3rd NCWG MEETING
Redlands, California, USA, 16-19 May 2017

Paper for Consideration by the Nautical Cartography Working Group (NCWG)
Contour lines discrepancies between ENC's of different usage bands
covering the same area

Submitted by:	IHO Secretariat
Executive Summary:	Based on a mariner's report complaining on the discrepancies between contour lines in two ENC's (UB4 and UB5) covering the same area, this paper invites the working group to consider whether the current regulations and chart specifications of the IHO in S-4 and any other documents are sufficient or not, And, if yes, if they are well applied.
Related Documents:	NSHC32-G9.1 ; HSSC8-05.3C; S-4.
Related Projects:	ENCWG Work Plan, Task L.

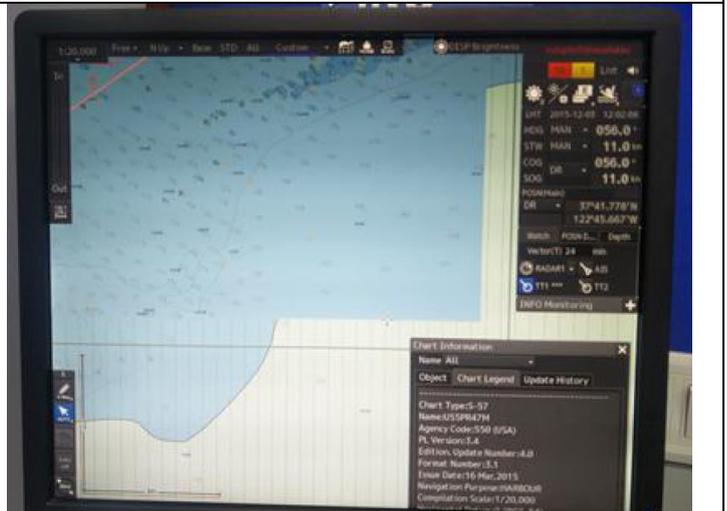
This screenshot shows the contour line of 182.8 m separating the light blue (indicating vessel “no go” area)* and white tints, derived from a paper chart/raster chart contour line of 600 ft.

This screenshot shows the effect of setting any safety depth with a value greater than 18.2 m: the entire sea coverage gets light blue.

4. Due to the quality of the information provided, it is not clear whether the 100 ft contour line, which exists on the equivalent paper/raster chart, has been encoded in the UB5 ENC or not. However, it is the opinion of the IHO Secretariat that a single outer depth area has been encoded on the UB5 ENC from the 18.2 m contour to the edge of the cell. This would result in the area being coloured blue (“no go” area) as the interpolation of the safety depth is based on the value populated for the DRVAL1 attribute for encoded depth areas (DEPARE), in this case the DRVAL1 of the outer depth area will be 18.2 m, corresponding to the bounding 18.2 m depth contour.

5. The mariner also claims that the 600 ft contour line in UB5 is close, but does not match accurately the same depth contour on the UB4.

8. In this case, the Secretariat is of the view that the cartographer should have encoded the entire contour line 182.8 m in the UB5 ENC, using the attribute QUAPOS = 4. The interruption of this contour line is likely not to be the best solution as far as safety of navigation is concerned.

9. In order to avoid such situations, it is recommended to review the appropriate sections of the IHO documentation (S-4, encoding bulletins) and to provide the cartographers with amended/additional guidelines, if appropriate.

10. Hydrographic Offices (HO) should, where possible, conduct systematic “vertical consistency” checks between UBs of ENCs covering the same area. Where possible, such checks should be supported by loading ENCs in ECDIS and systematic display checks (zoom-in, zoom-out between UBs and their effects on safety depth display).
